**re: Grading & Servicing Plan Review**  
Proposed Multi-Storey Building  
1166 Bank Street – Ottawa, Ontario

**file:** PG6191-MEMO.02

# Figure 1 - Servicing Plan Review

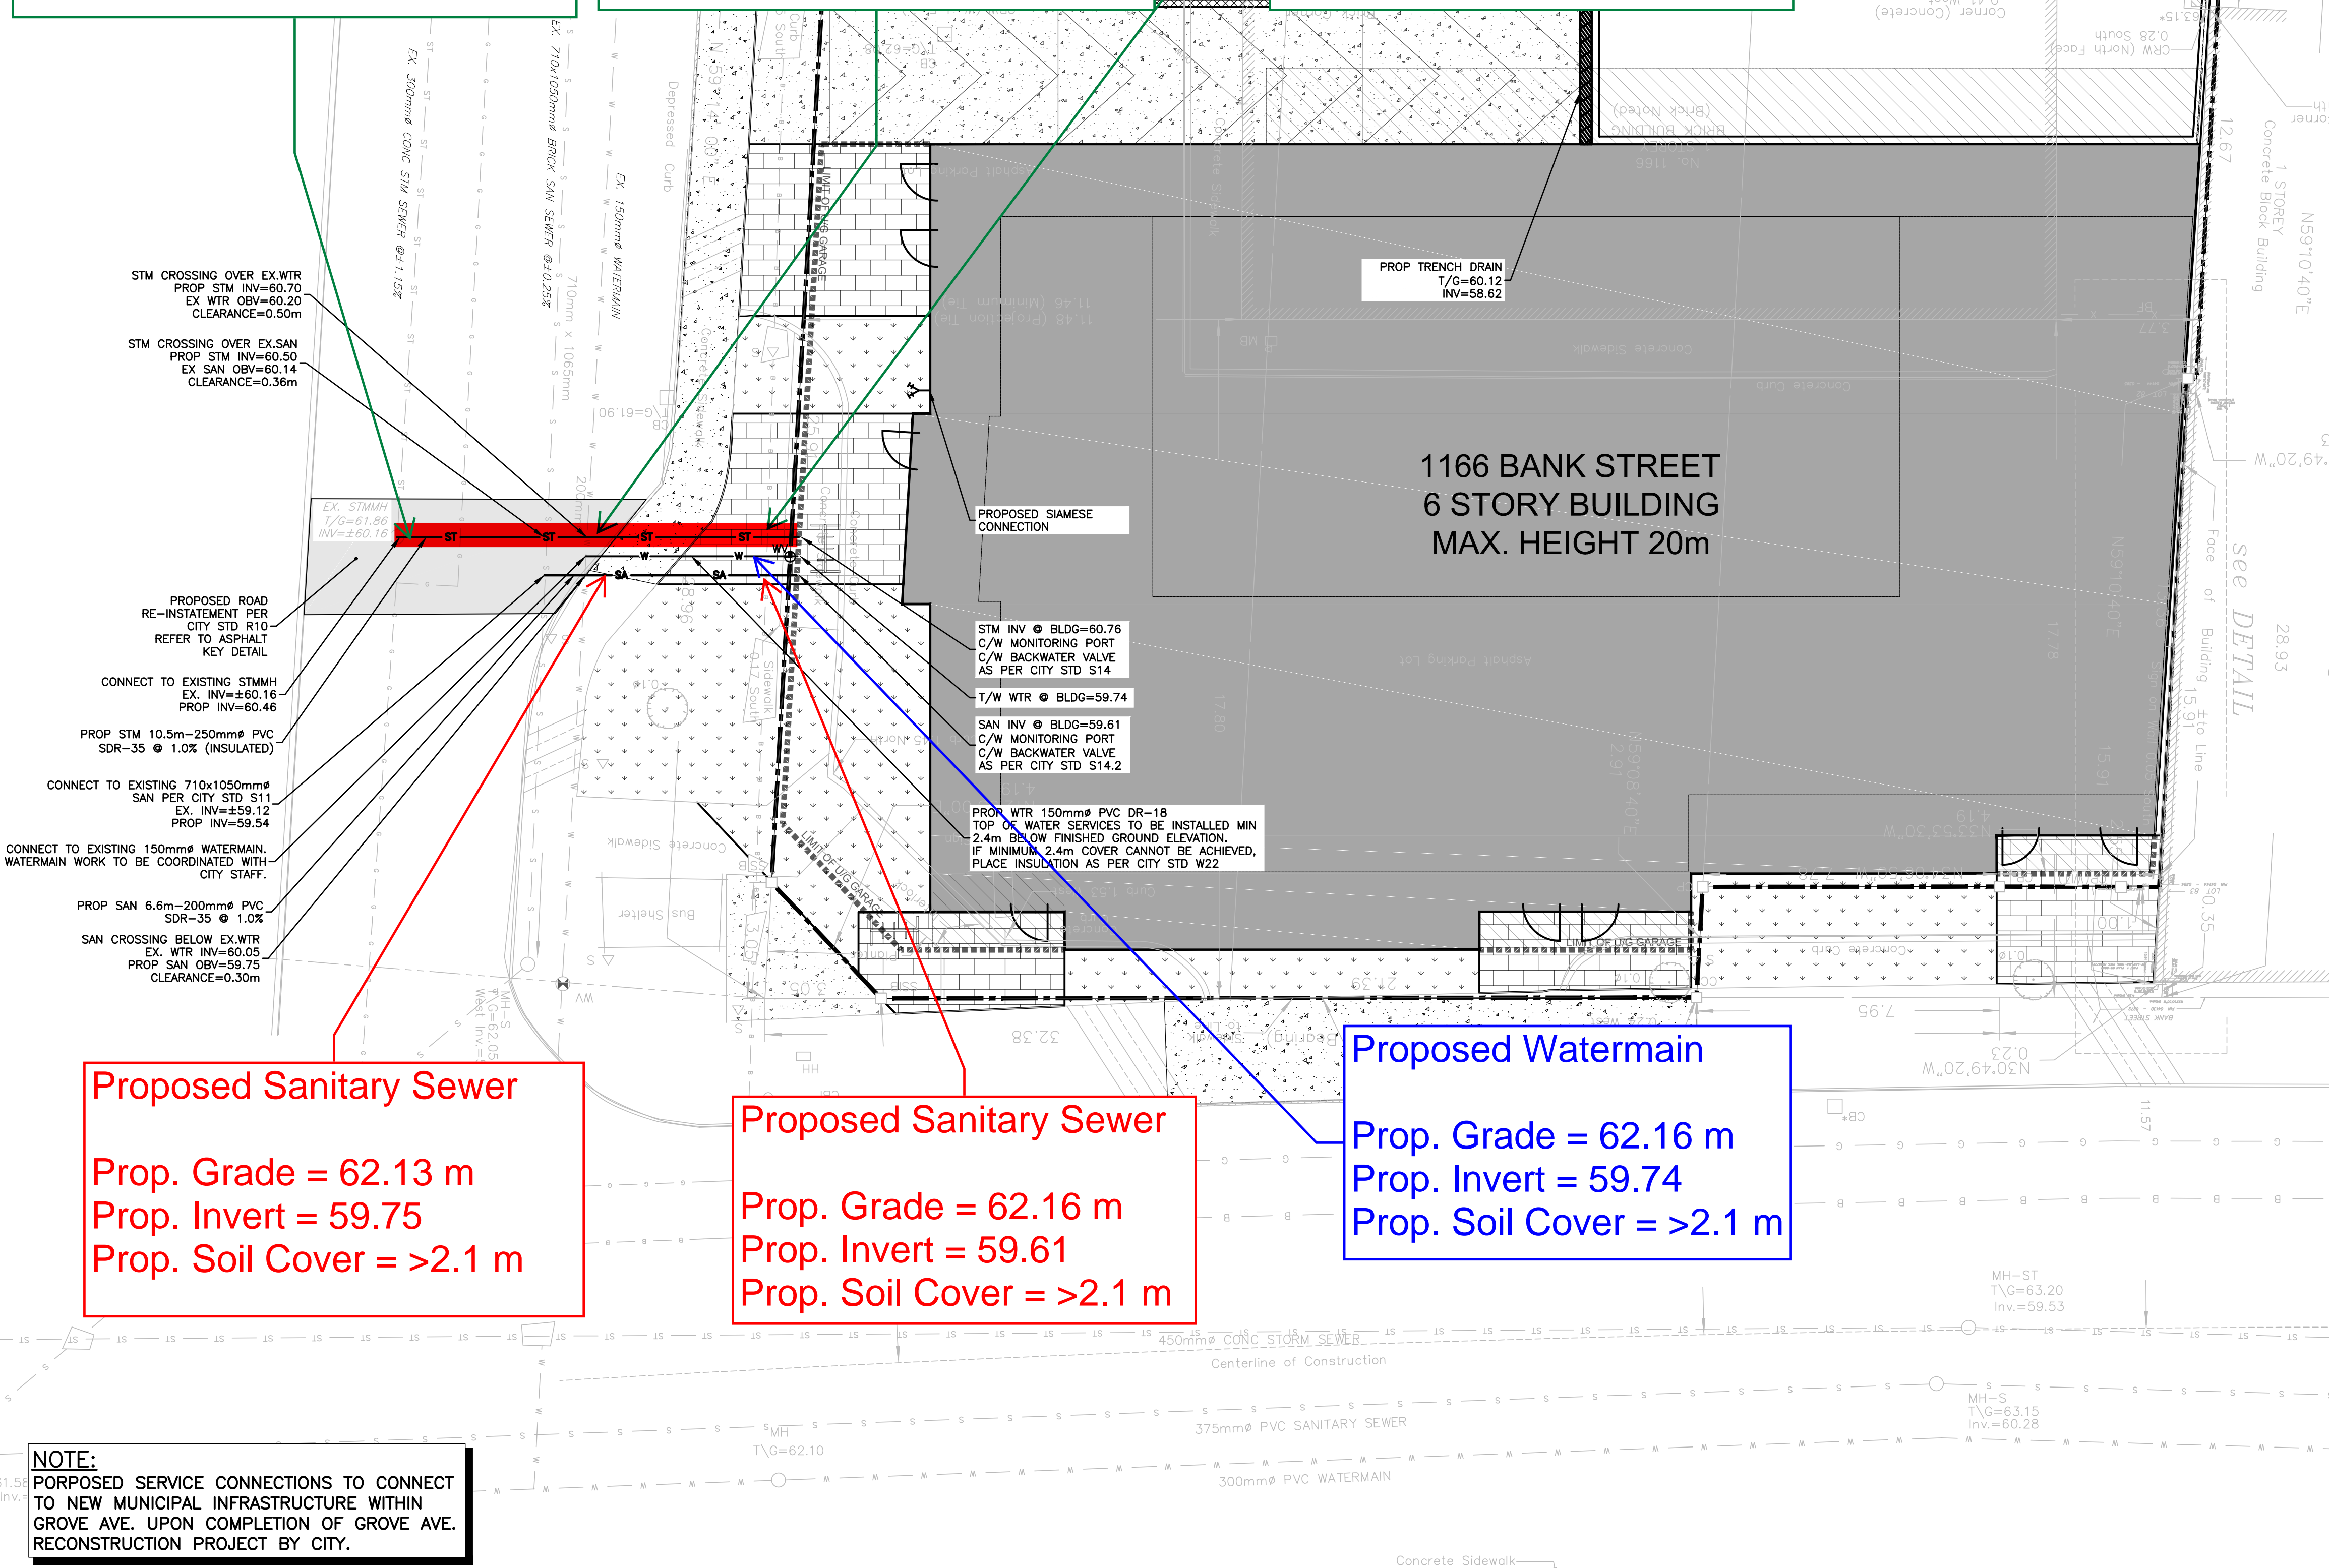
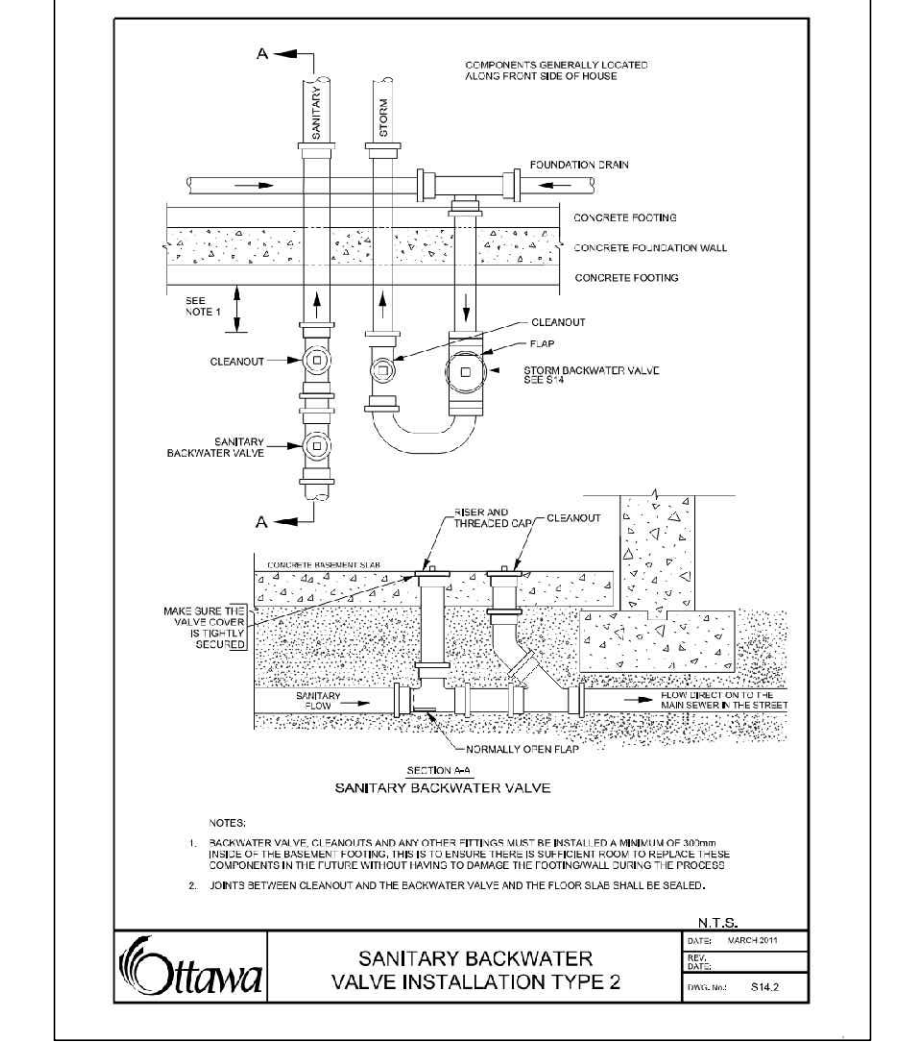
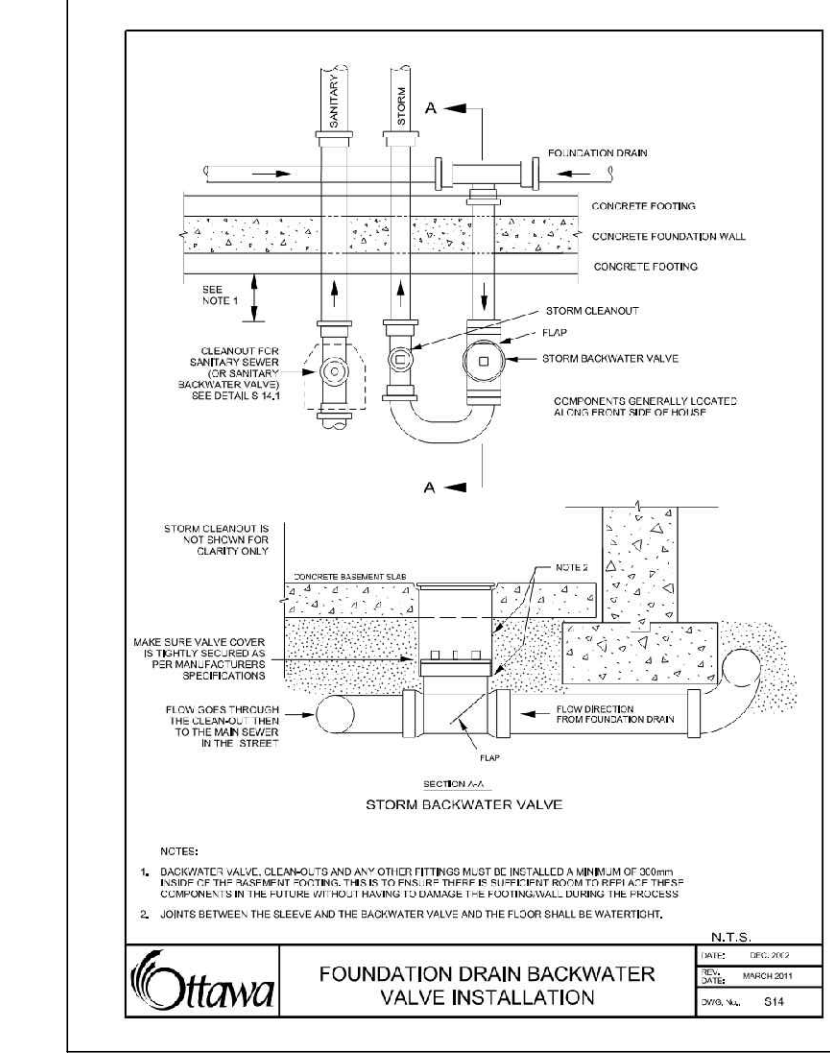
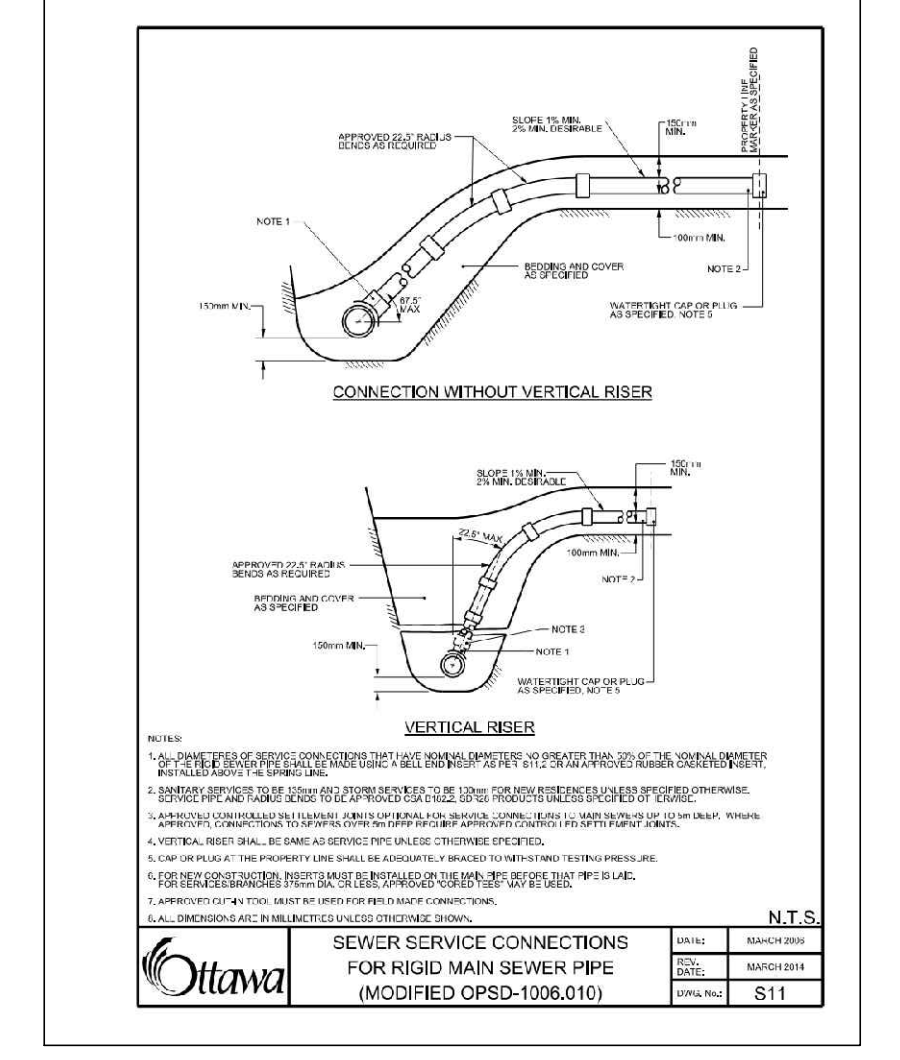
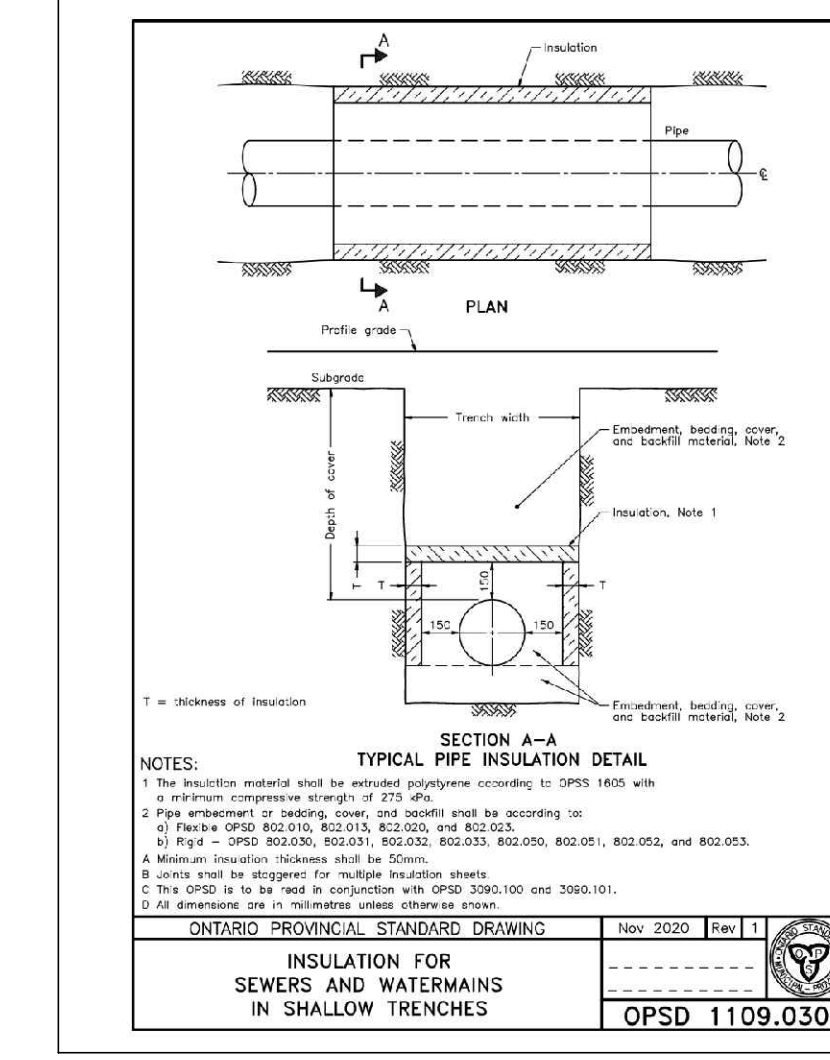
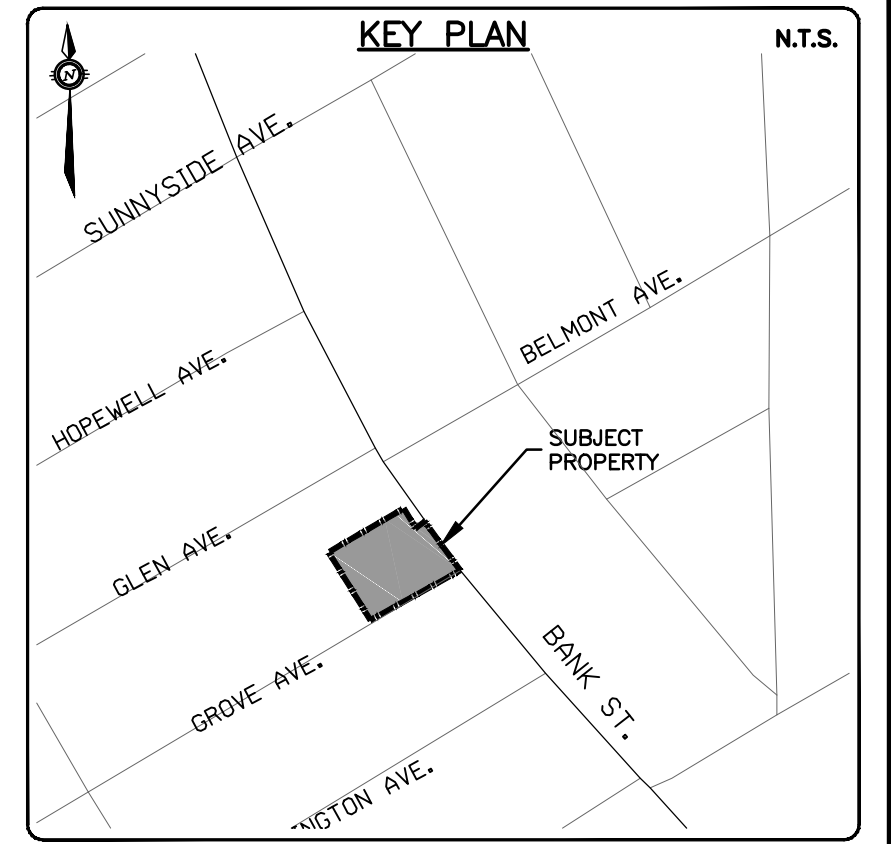
Based on our review of the site servicing plan, sufficient soil cover has been provided to the proposed watermain and sanitary services. However, insufficient soil cover was noted to be provided to the proposed stormwater service. Where insufficient soil cover (i.e. less than 2.1 m of soil cover is present above the obvert of the pipe) is available, the following frost protection criteria outlined in Table 1 should be followed. Please refer to Figure 1 – Servicing Plan Review attached which indicates the frost protection provided to each service.

## Proposed Stormwater Sewer

Ex. Grade = 61.86 m  
 Prop. Invert = 60.46  
 Prop. Soil Cover = < 2.1 m

## Proposed Stormwater Sewer

Prop. Grade = 62.13 m  
 Prop. Invert = 60.70  
 Prop. Soil Cover = < 2.1 m

## Proposed Stormwater Sewer

Prop. Grade = 62.16 m  
 Prop. Invert = 60.76  
 Prop. Soil Cover = < 2.1 m

<b>Table 1 - Rigid Insulation Recommendations for Storm Sewer and Water Pipes with Reduced Soil Cover</b>			
<b>Thermal Condition</b>	<b>Soil Cover Provided (mm)</b>	<b>Insulation Dimensions</b>	
		<b>Thickness (mm)</b>	<b>Extension (mm)</b>
Unheated	600 to 900	125	Extend 1200 mm horizontally beyond edge face of the pipe
	900 to 1200	100	Extend 1200 mm horizontally beyond edge face of the pipe
	1200 to 1500	75	Extend 900 mm horizontally beyond edge face of the pipe
	1500 to 1800	50	Extend 600 mm horizontally beyond edge face of the pipe
	1800 to <2100	25	Extend 300 mm horizontally beyond edge face of the pipe

All rigid insulation should consist of either Dow Chemical High-Load 40 (HI-40), Styro Rail SR.P400, or equivalent approved by Paterson. The placement of all insulation within the service trenches must be reviewed and approved by Paterson personnel at the time of construction.
